RECORD OF DECISION

HANFORD 200 AREA

200-CW-5 AND 200-PW-1, 200-PW-3, AND 200-PW-6

September 2011

Figure 1: Testing of 200-CW-5 by Year – the trenches are approximately two miles long:

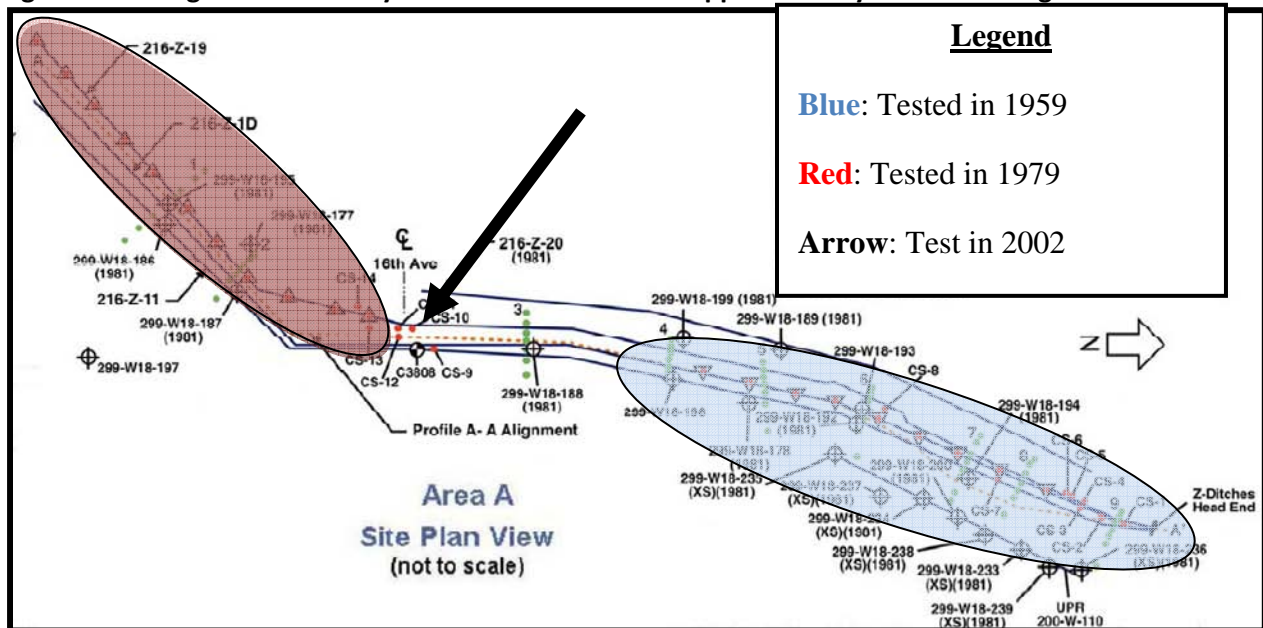
USDOE has not adequately characterized the soil in the 200-CW-5 OU area — except for one borehole in the two-miles of trenches, USDOE has not collected any data since 1979, as illustrated by Figure 1 (below).

Therefore, while USDOE's characterization of the substances in these ditches states, "Contamination now 1 to 0.6 m (2 ft) deeper at locations sampled before 1981 due to addition of stabilization material," it has no recent data to support this presumption. Feasibility Study for the 200-CW-5 Cooling Water Operating Unit 2-21, Table 2-3. Rather, the testing fails to "characterize the areal and vertical distribution" of the hazardous substances, in violation of WAC 170-340-350(7)(c)(iii)(B).

Figure A-1: Visualization of the plutonium underneath the 216-Z-1, Z-2, Z-3 Cribs and Z-1A Tile Field viewed from the west.

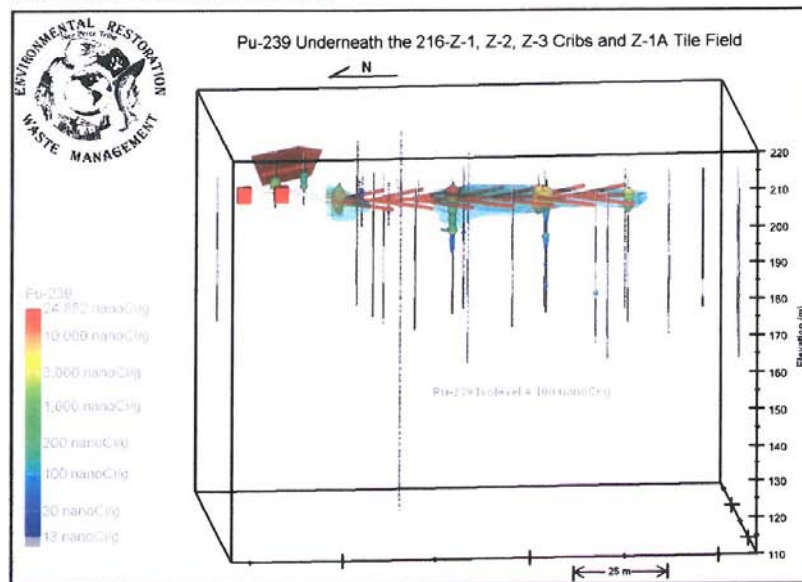
We believe that there was substantially more plutonium released at the 216-Z-1A Crib and tile field than has been reported. The Feasibility Study and RHO-SA-131 indicate that 57 kg of plutonium and 1 kg of Am-241 were released at this site. Based on our kriging of the area that encompasses only the B and C sections of the 216-Z-1A tile field, we estimate that the vadose zone contains 71 kg of plutonium (Figure A-1). RHO-SA-113 reported that a total of 27.4 kg of plutonium was discharged in the "B" and "C" sections. It is worthy of note that our kriging estimate for Am-241 for the whole tile field is approximately 0.5 kg (Figure A-2).

We recommend soil excavation to a maximum depth of 55 ft below ground surface (bgs) which should remove all actinides with activities greater than 100 nanoCi/g. After treatment to reduce volume, these actinides should be disposed at WIPP.

Figure A-3: Logging results for borehole 299-W18-159 from SGW-42004.

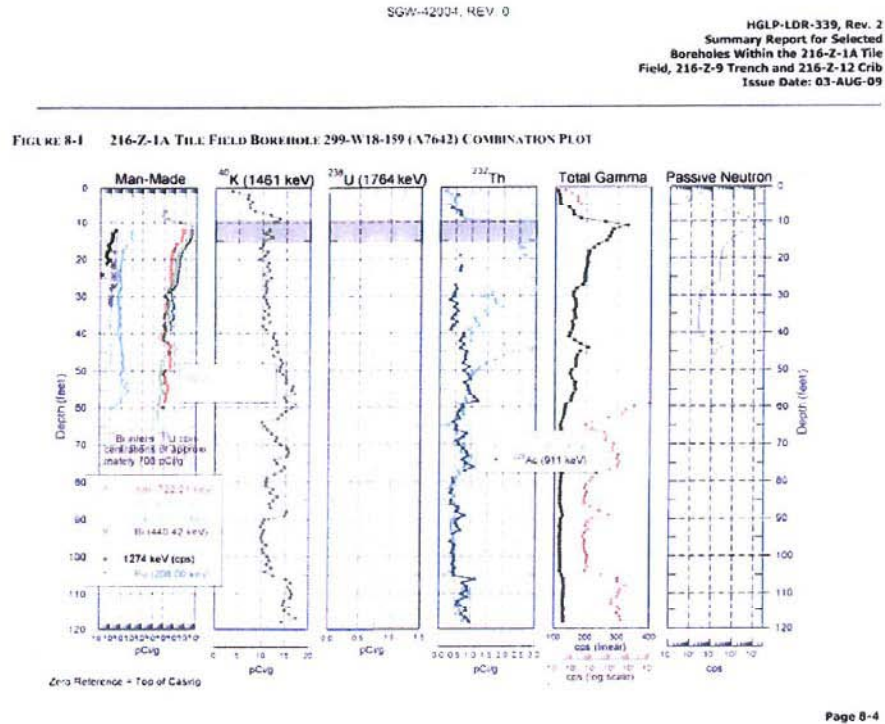
Logging results at the 299-W18-159 borehole (Figure A-3), which is located near the central distributor pipe, indicate neutron count rates greater than 1,000 per second at ten feet below the surface. Neutrons have a relatively high relative biological effectiveness, and are roughly ten times more effective at causing cancers compared to photon or beta radiation of equivalent radiation exposure. The risk scenarios should include a section on neutron and neutron-gamma ray activation exposure before a final remedy is selected.

216-Z-9 Trench

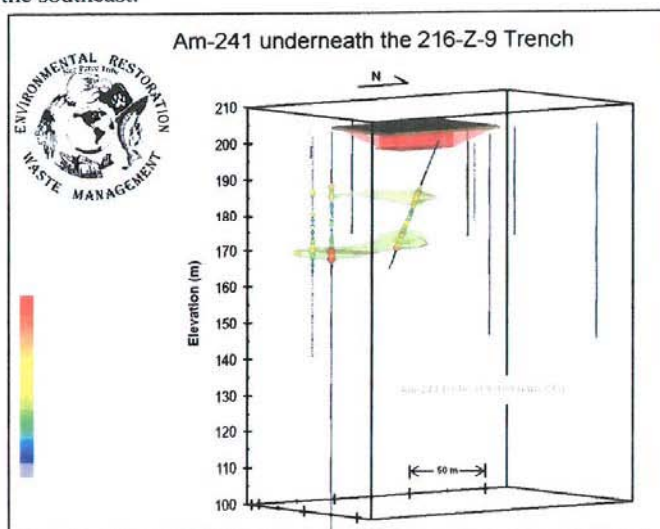
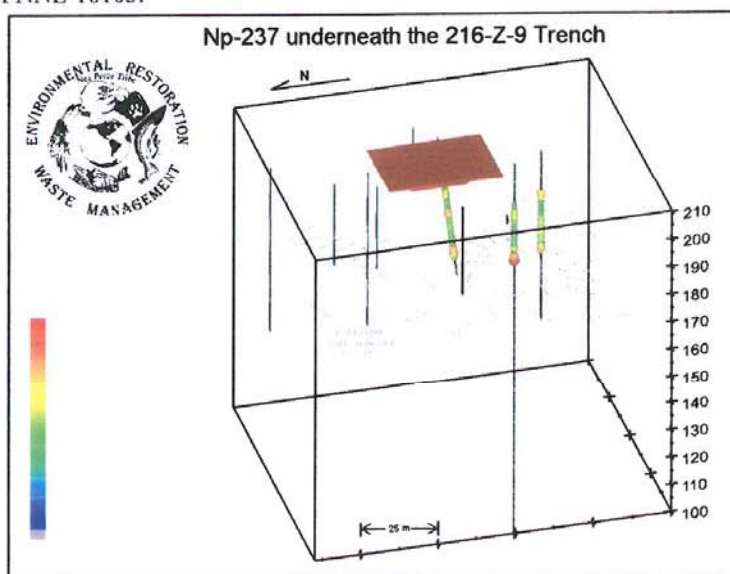
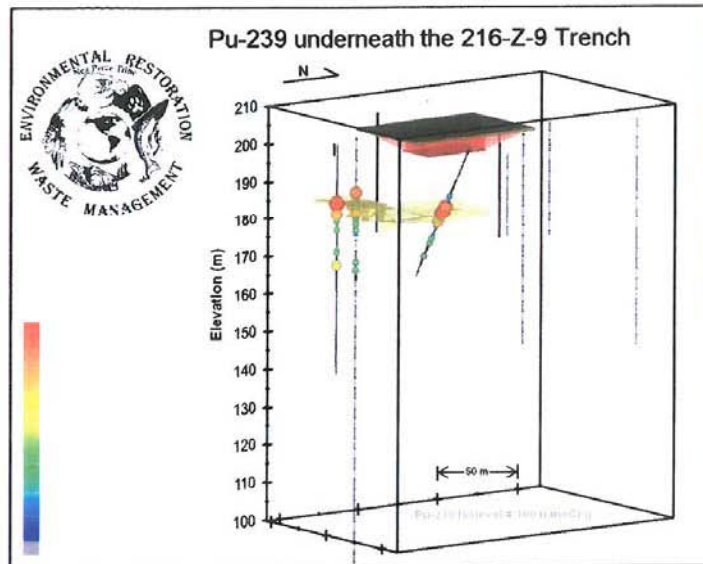
The distribution of actinides underneath the 216-Z-9 Trench needs additional characterization (Figures A-4, A-5 and A-6). Actinides have migrated to the southwest beyond the footprint of the 216-Z-9 Trench. In the vadose zone, the highest values for Am-241 and Np-237 were detected at well 299-W15-46, deep in the vadose zone and near the top of the caliche within the Cold Creek unit. Actinides have migrated further and deeper at this trench than the other waste sites in the 200-PW-1 Operable Unit. While the highest levels of plutonium were detected at slant hole 299-W15-48 underneath the trench, the highest levels of Am-241 and Np-237 are detected significantly deeper than plutonium in the vadose zone at well 299-W15-46. At well 299-W15-46, Am-241 and Np-237 were detected at depths of 116 ft and 118 ft at 400 nCi/g and 29 pCi/g, respectively. Although actinides haven't been detected below the caliche, the full extent of the actinide migration is unknown. Actinides may have migrated into the Ringold formation through an erosional window in the caliche located to the southwest of the trench.

Figure A-7: Visualization of the plutonium-239 underneath the 216-Z-12 Crib viewed from the west.

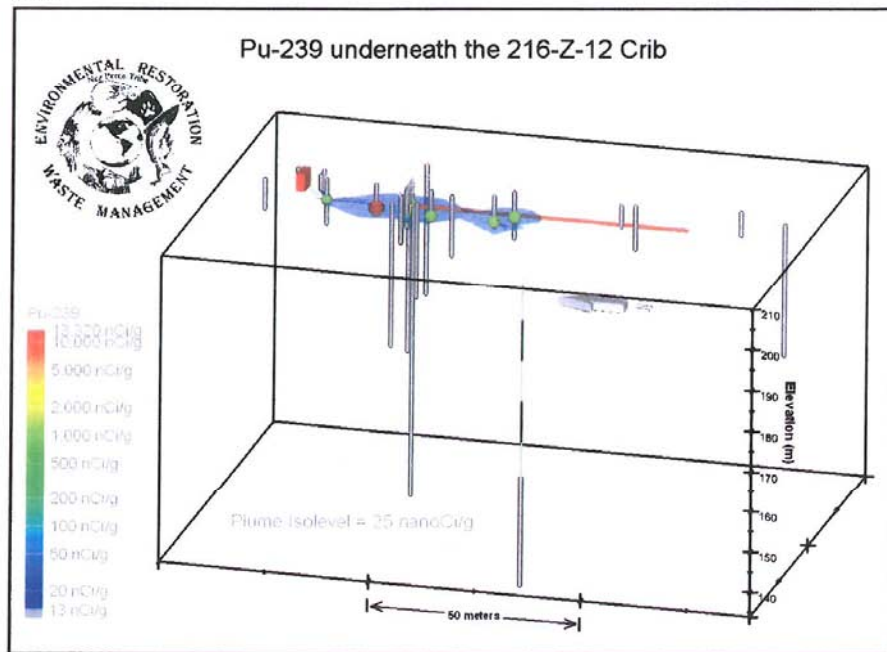
Unlike other Z waste sites, the plutonium-239 (activities greater than 25 nanoCi/g) underneath the 216-Z-12 Crib appears to be located within 10 ft of the distribution pipe (Figure A-7). The distribution of plutonium underneath the crib supports DOE's contention that in some cases plutonium is relatively immobile since this crib released more than 74 million gallons of waste to the vadose zone.

The assertion that 100% of the plutonium with activities greater than 100 pCi/g underneath the 216-Z-12 Crib is within 24 ft of the surface, on page 5-19 (Figure 5-5) of the Feasibility Study, is incorrect. Logging results from borehole 299-W18-181 (Figure A-8) indicate that plutonium-239 at activities of 100 nanoCi/g has reached 32 ft bgs (35 ft log depth). Thus, the cost of the remove, treat and dispose options 3D and 3E need to be recalculated to account for the plutonium below 24 ft bgs.

Figure A-9: Logging results for borehole 299-W18-162 from HGLP-LDR-211, Rev. 0

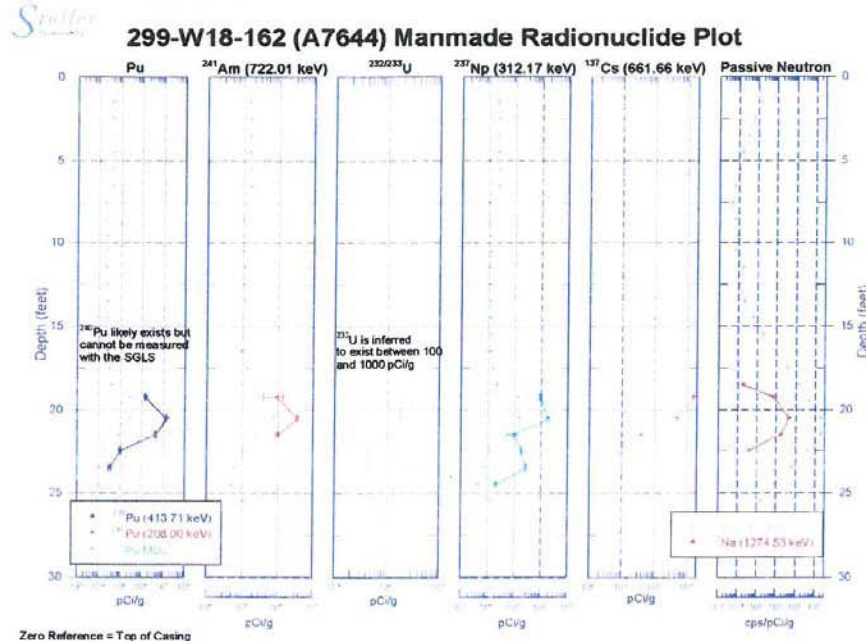
Logging results at the 299-W18-162 borehole (Figure A-9), which is located near the waste distribution pipe, indicate neutron count rates greater than 1,000 per second at 21 ft log depth. Neutrons have a relatively high relative biological effectiveness, and are roughly ten times more effective at causing cancers compared to photon or beta radiation of equivalent radiation exposure. The risk scenarios should include a section on neutron and neutron-gamma ray activation exposure before a final remedy is selected.

Figure A-10: Elevated gamma radiation isopach map of the 216-Z-18 Crib from DOE/RL-91-58.

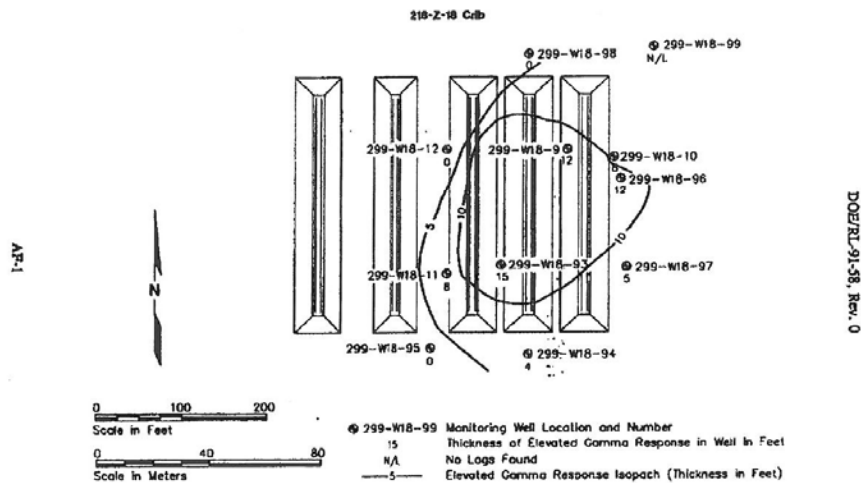
The distribution of actinides underneath the 216-Z-18 Crib needs additional characterization. Over one million gallons of waste was released at this crib, which drove actinides deep into the vadose zone and to the south and east beyond the footprint of the 216-Z-18 Crib (Figure A-10). In addition to boreholes 299-W18-9 and -10, which were reported in the Feasibility Study (p. 2-59), boreholes 299-W18-11, -93, -94, and -96 detected radiation above background as shown in Figure A-9 (DOE/RL-91-58).

Pending the outcome of additional characterization, we recommend soil excavation to a maximum depth of 61 ft bgs, which should remove all actinides with activities greater than 100 nanoCi/g. After treatment to reduce volume, these actinides should be disposed at WIPP.
